# GROVE BARTON RETAIL ADDITION

## SR-32-2018 / S-15-18

# Administrative Approval Action

SR-32-18 & S-15-18 Grove Barton Retail Addition  
Transaction # 550847, AA # 3834 (Subdivision) and # 3836 (ASR)

PROJECT NO: ORA-1601  
FILENAME: ORA1601-DP  
DRAWN BY: RCN  
SCALE: 1" = 20'  
DATE: 12-10-12  
SHEET NO: C-1

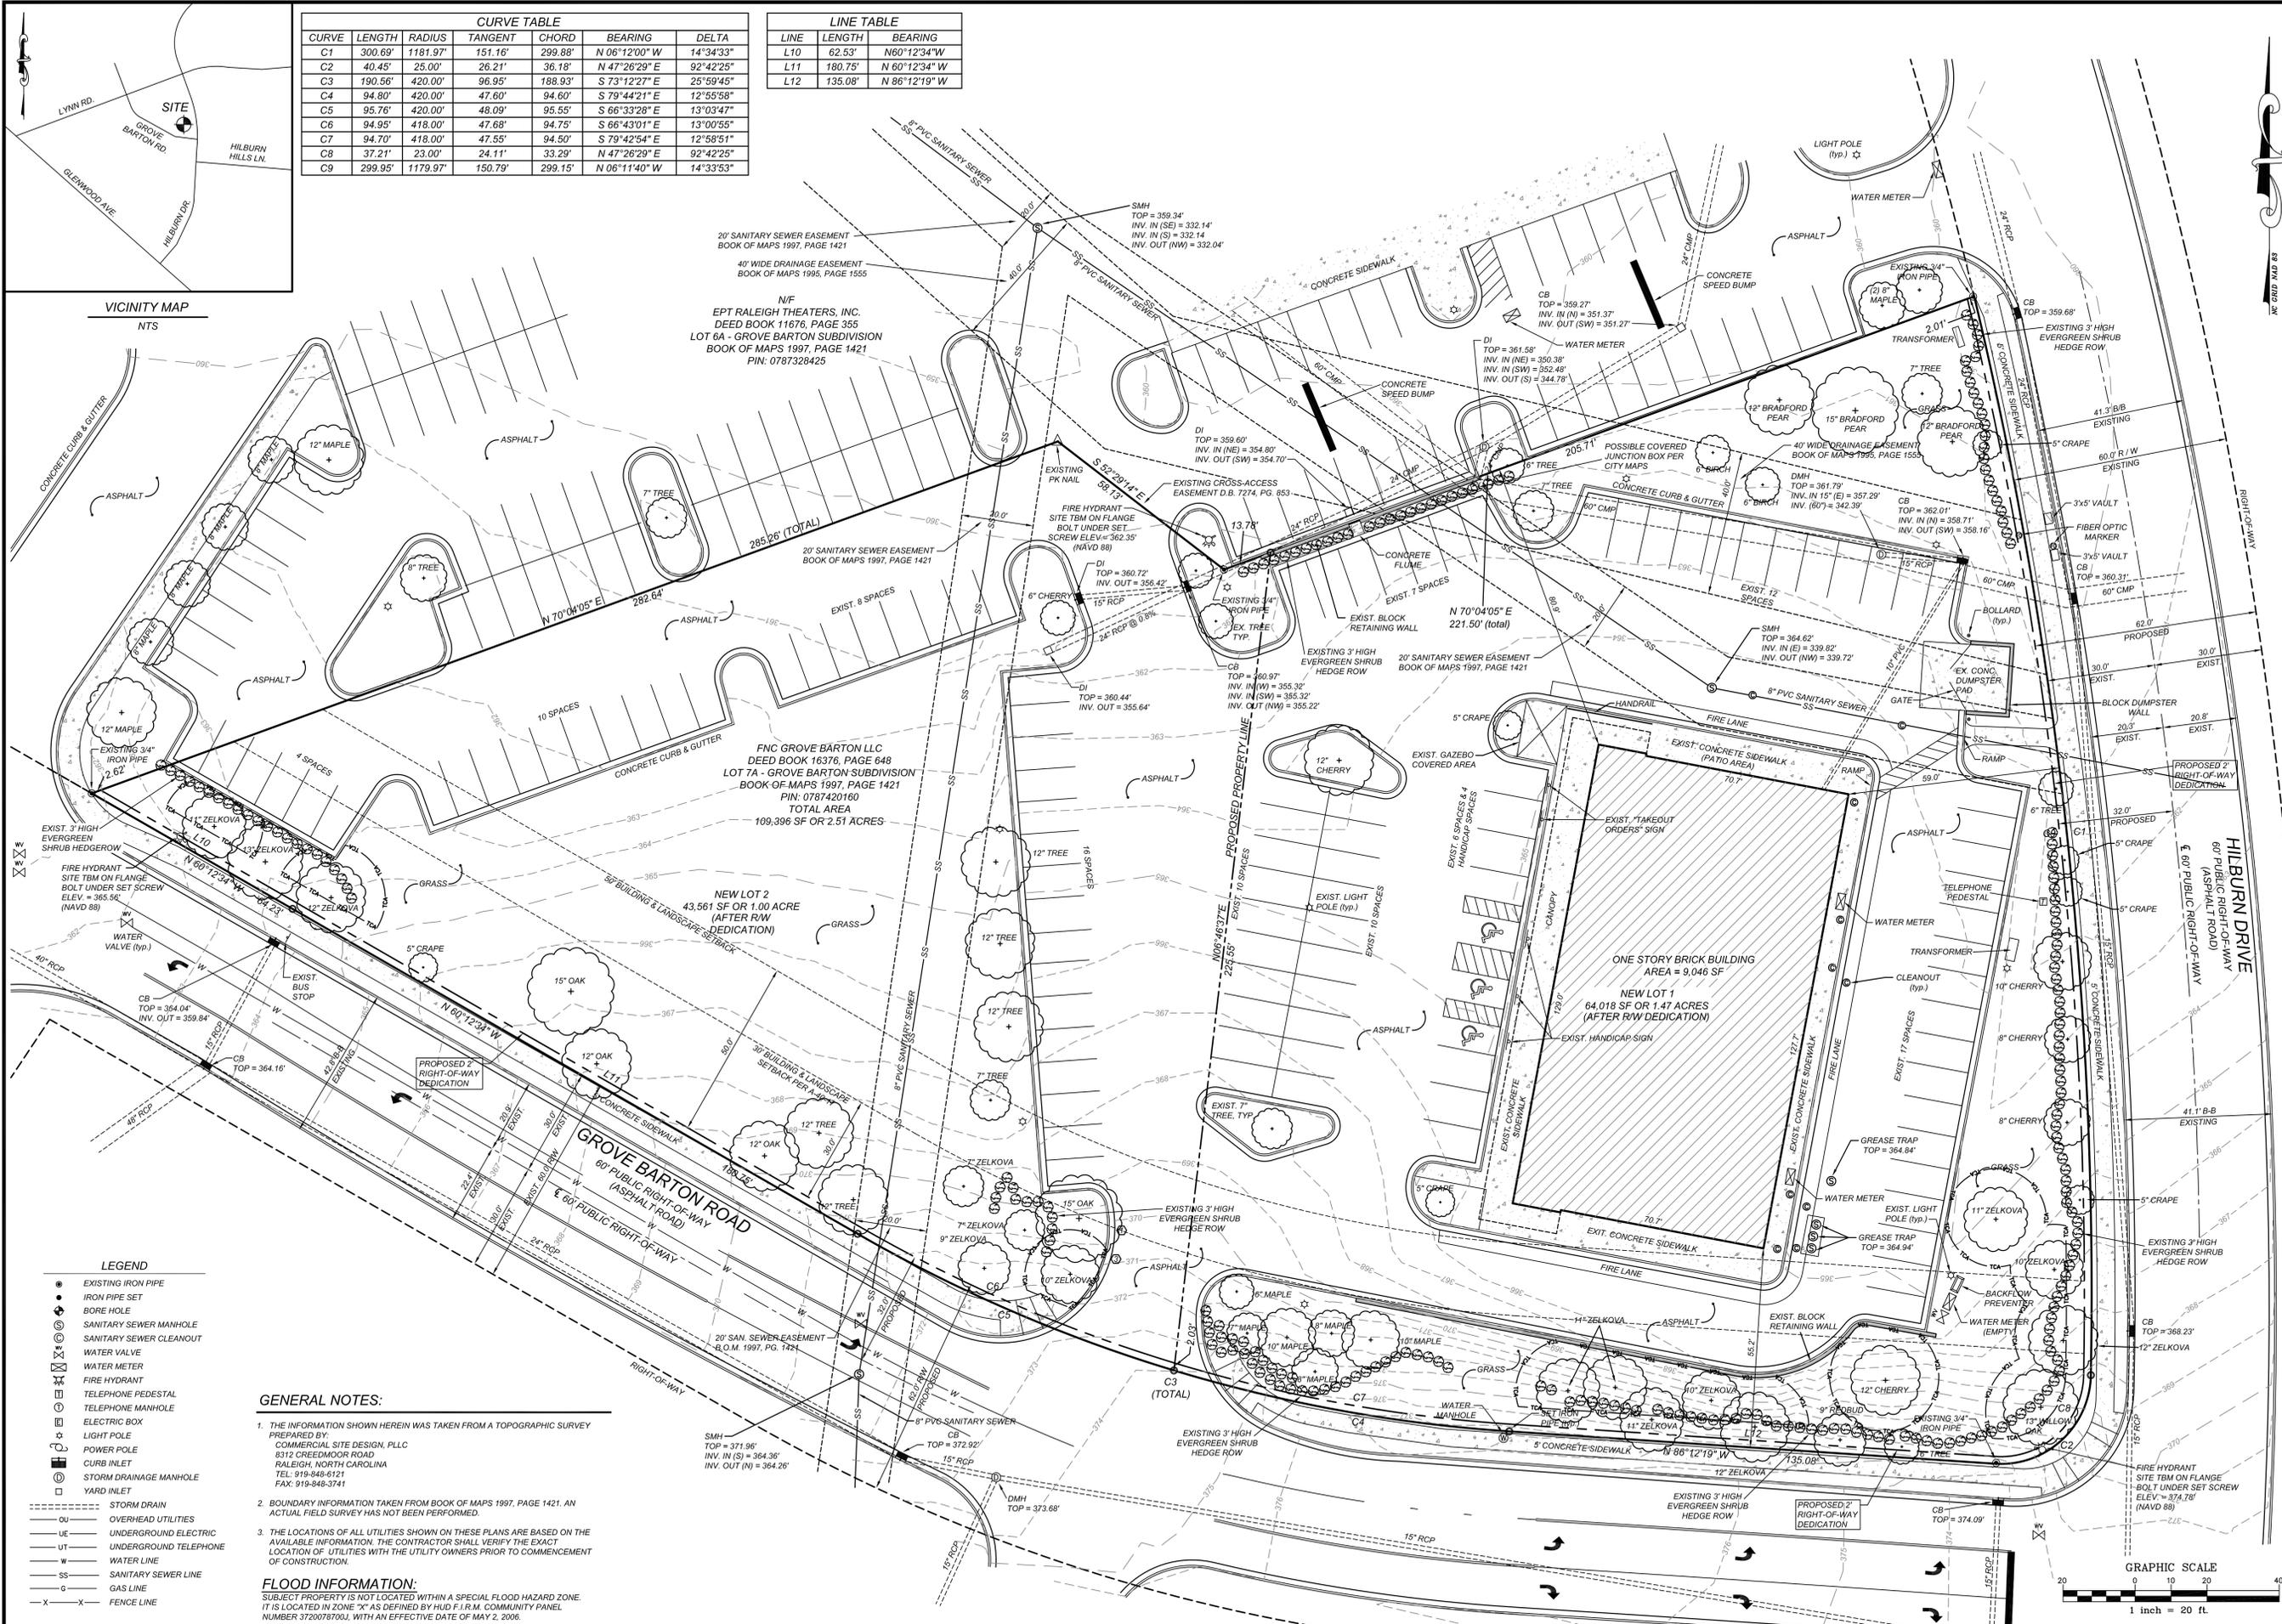
1. The Existing Conditions Sheet (C-1 in ASR plans) will not show proposed property lines in Concurrent Site Plans.
2. Sheet C-2, as shown in ASR plans, will be labelled “Proposed Subdivision & Site Plan” in Concurrent Site Plans.
